The BACW's Bidding Commission hereby presents questions made by companies with their respective answers.

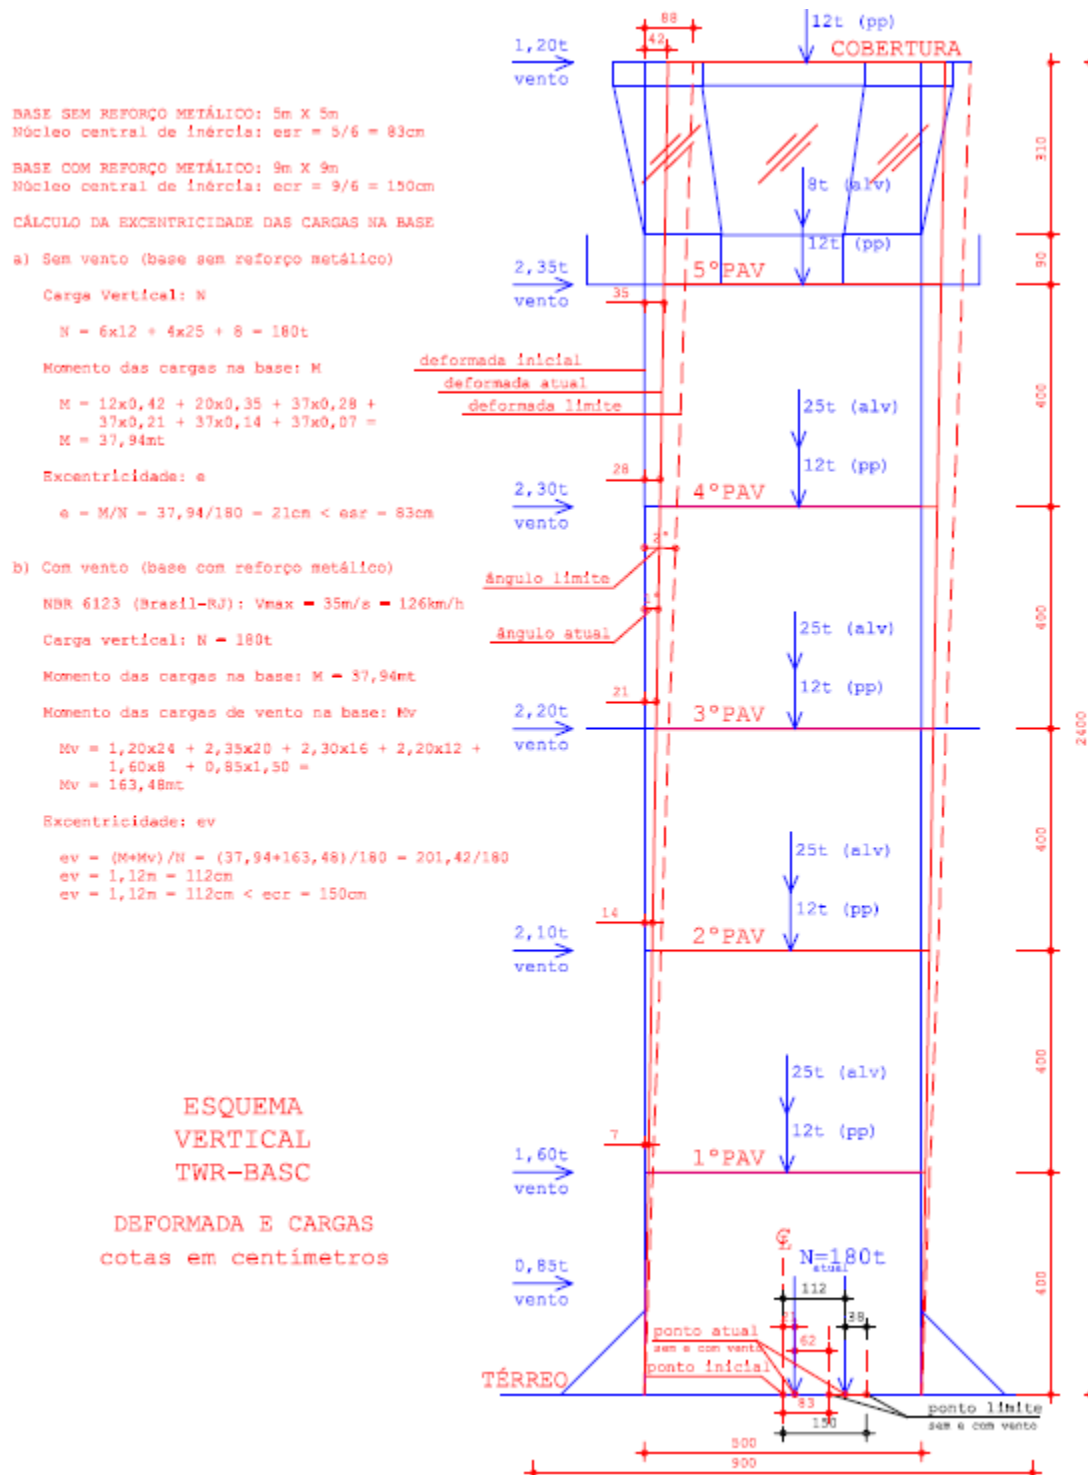
6. Question – Please kindly confirm total height of existing ATC Control Tower.

ANSWER: The ATRW-SC measures 24 meters as per the drawing below.
